ENGINEERING CHANGE NOTICE

1. ECN 187757
Proj. ECN B-714-155

| 5. Project Title/No./Work Order No. Grouted Waste Disposal Facilities B-714/ER8007 | | 6. Bldg./Sys./Fac. No. 218-E-16 | | 7. Impact Level 3Q/SC-2 |

12. Description of Change SC-2

| Ref. Dwg. H-2-77602 | Sh. 1 | Rev. 1 | Prepared By T.K. EHRHARD | Checked By <i>M.A. McLean</i> | ECN No. B-714-155 | Page 417 |

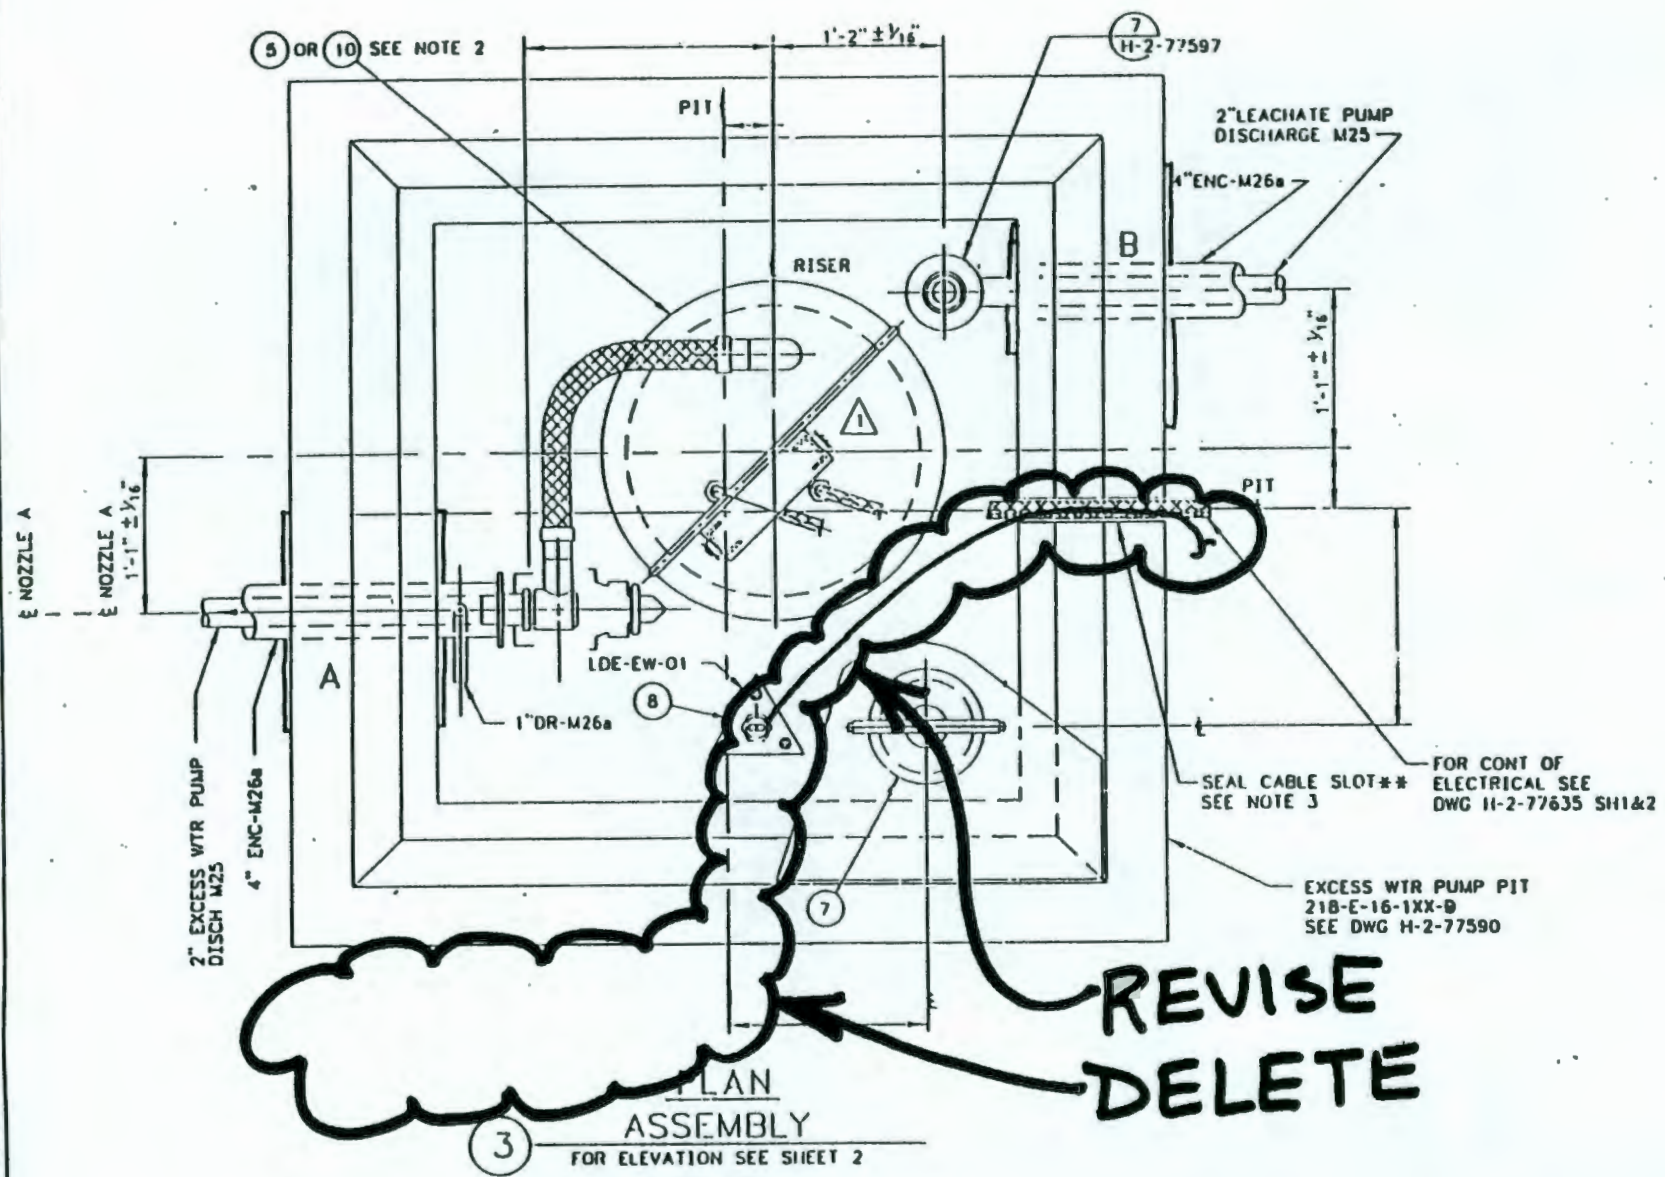
- 2) H-2-77590, Sh 1, Rev 1
 Arrangement Plan (Z C3): At pit plan 102-D/103-D DELETE the SOUTH wall Conductor Slot and supporting 3'-0" dimension.
- 3) H-2-77602, Sh 1, Rev 1
 Plan, Assy 3 (Z E3-D4): Modify - see page 4 of this ECN.
- 4) H-2-77602, Sh 2, Rev 2
 Plan (Z E2-D3): Modify - see page 5 of this ECN.
- 5) H-2-78464, Sh 1, Rev 1
 Arrangement Plan (Z C3): At pit plan 104-D/105-D DELETE the SOUTH wall Conductor Slot and supporting 3'-0" dimension.
- 6) H-2-78473, Sh 1, Rev 1
 Plan, Assy 3 (Z E3-D4): Modify - see page 6 of this ECN.
- 7) H-2-78473, Sh 2, Rev 2
 Plan (Z E2-D3): Modify - see page 7 of this ECN.

**REVISE
DELETE**

NOTE: SEE EXCESS WTR PUMP PIT PLAN ON SH 2 FOR ALTERNATE JUMPER ARRANGEMENT

Ref. Dwg. H-2-77602

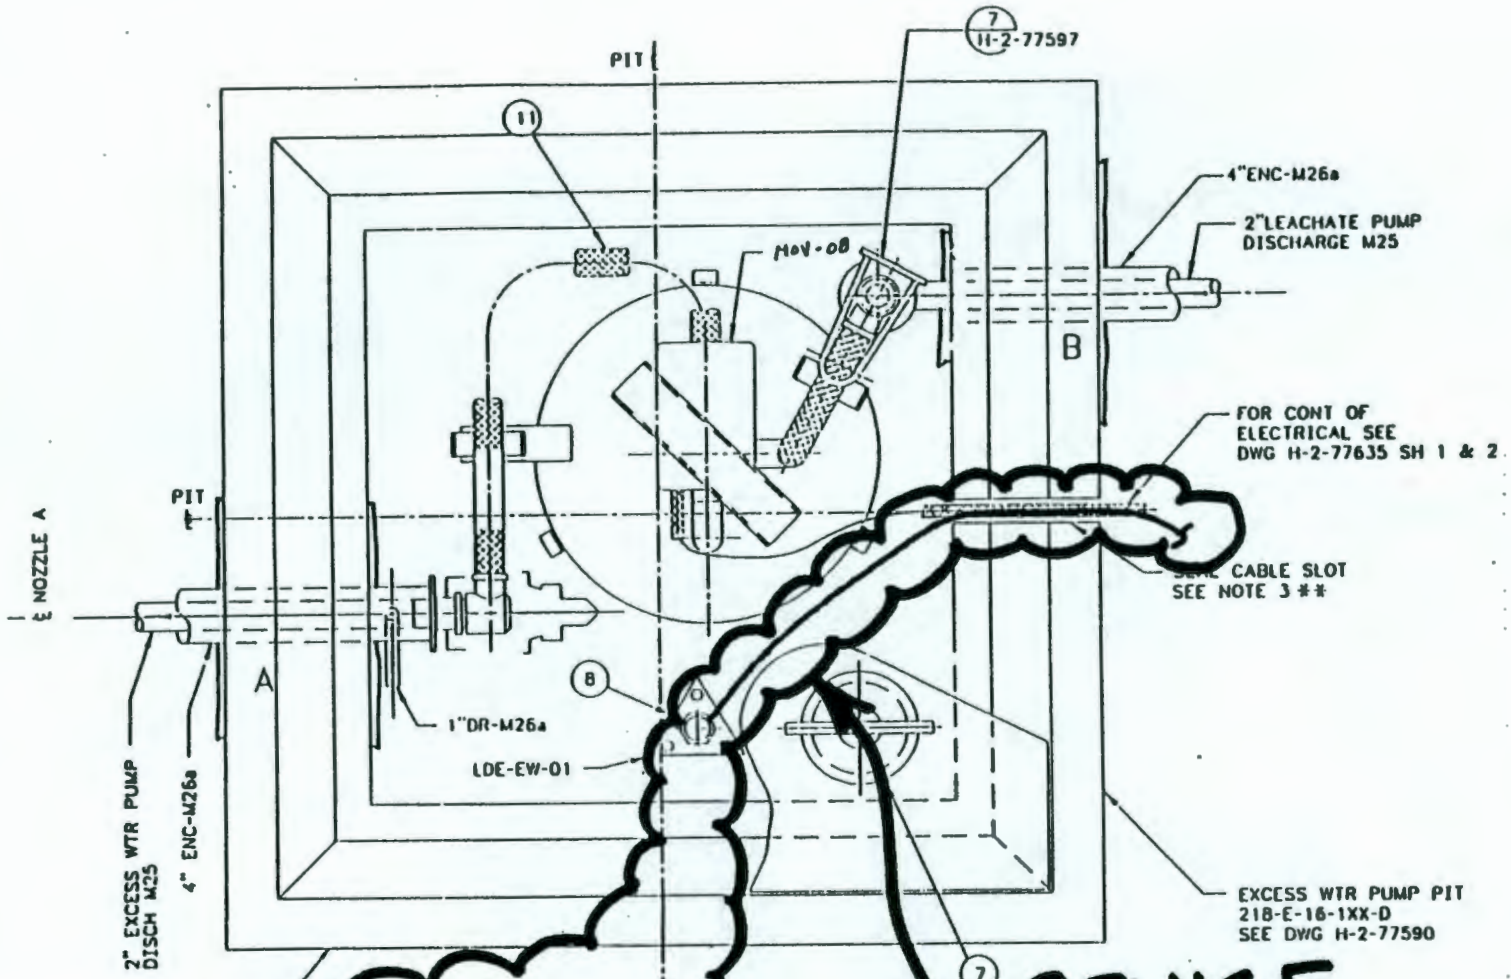
**REVISE
DELETE**

FOR EXCESS WTR PMP PIT PLAN, SECT AND DET SEE DWG H-2-77590

(ALTERNATE JUMPER ARRANGEMENT)

| Ref. Dwg. H-2-78473 | Sh. 1 | Rev. 1 | Prepared By T.K. EHRHARD | Checked By <i>M.A. McLean</i> | ECN No. B-714-155 | Page 617 |

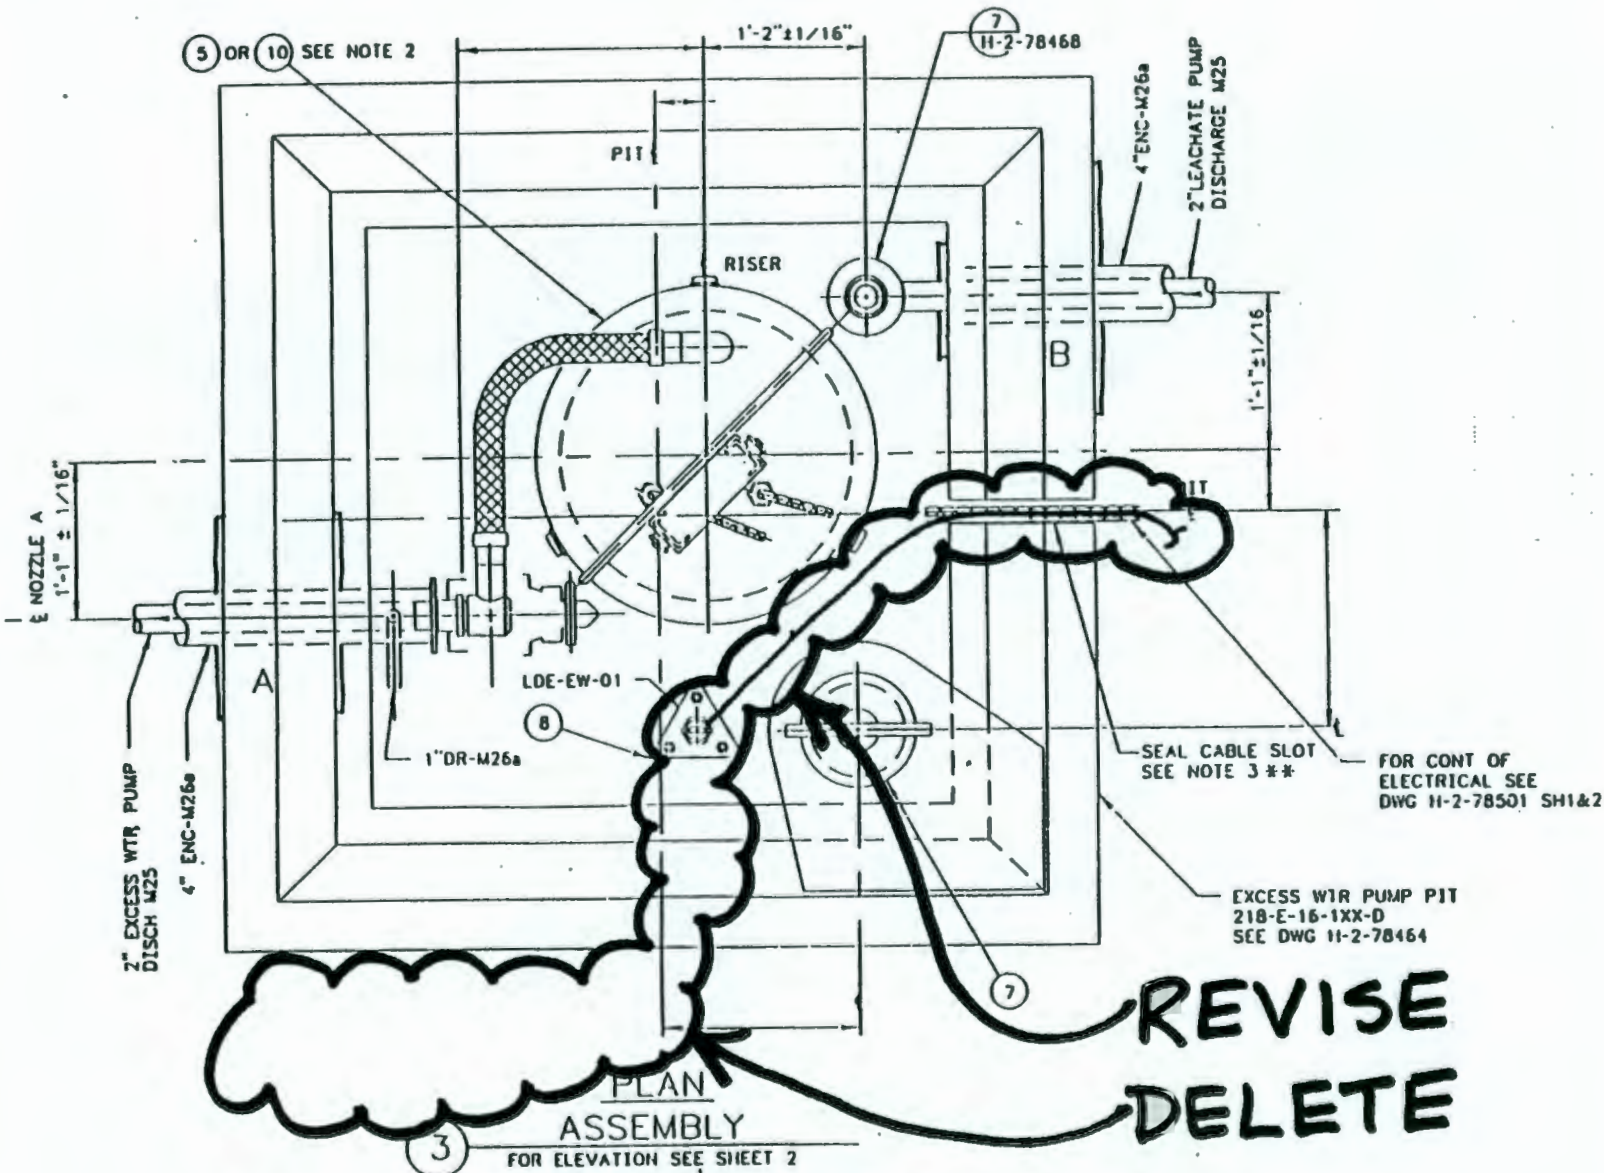
**REVISE
DELETE**

3
PLAN ASSEMBLY
 FOR ELEVATION SEE SHEET 2
 NOTE: SEE EXCESS WTR PUMP PIT PLAN ON SH 2
 FOR ALTERNATE JUMPER ARRANGEMENT

| Ref. Dwg. | H-2-78473 | Sh. | 2 | Rev. | 2 | Prepared By | T. K. EHRHARD | Checked By | <i>M. A. McLean</i> | ECN No. | B-714-155 | Page | 717 |

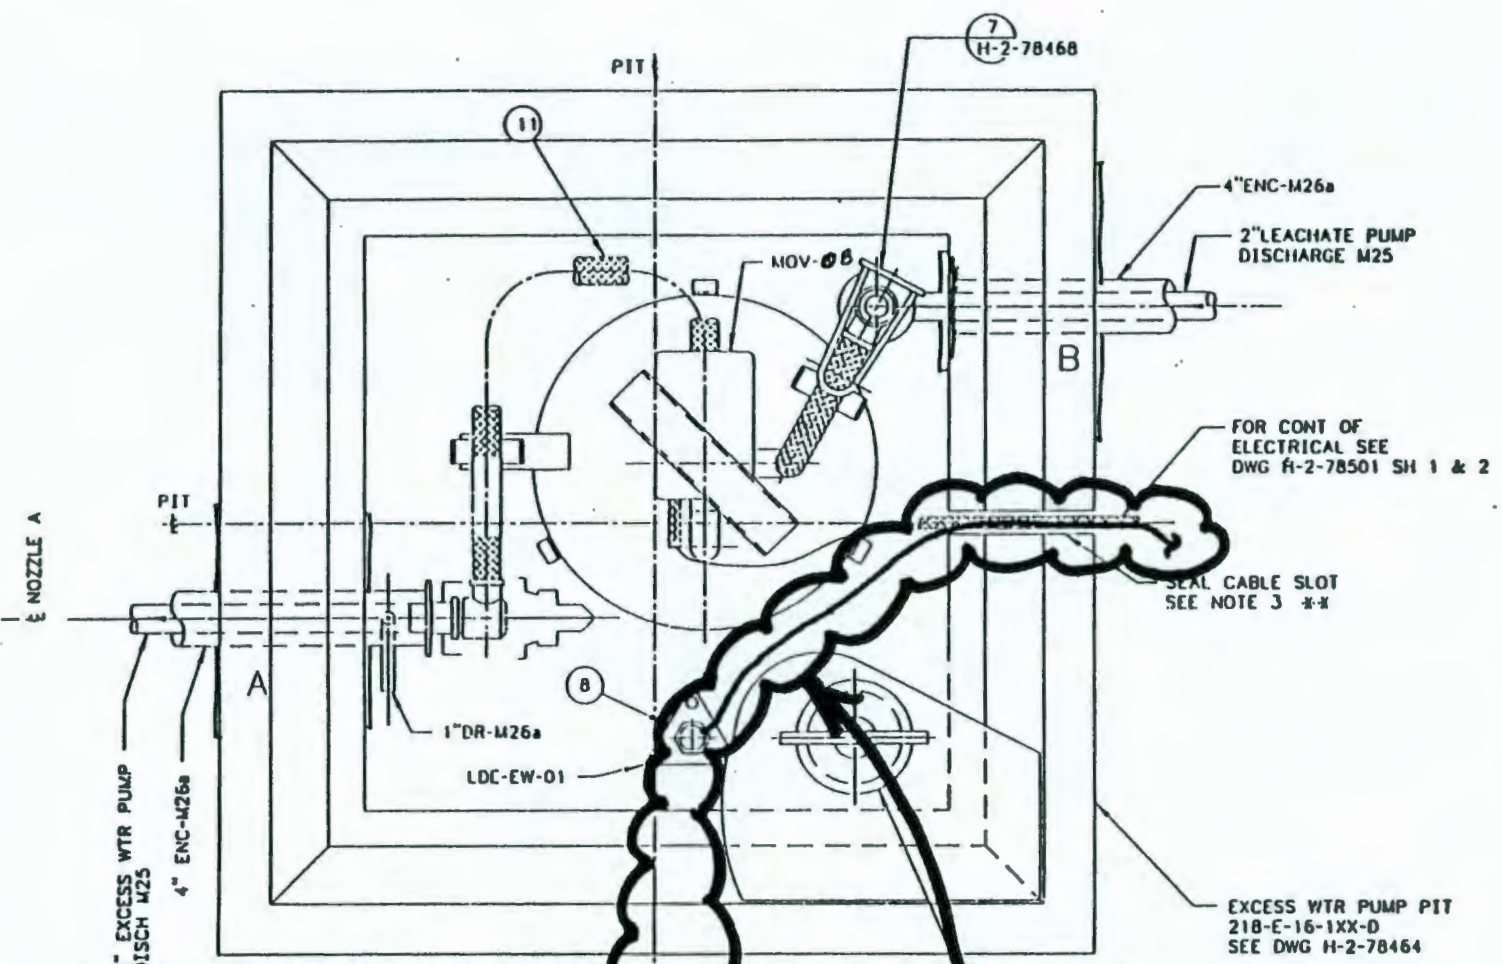
**REVISE
DELETE**

(ALTERNATE JUMPER ARRANGEMENT)
PLAN
(SIMILAR TO ASSY 3 ON SH 1)
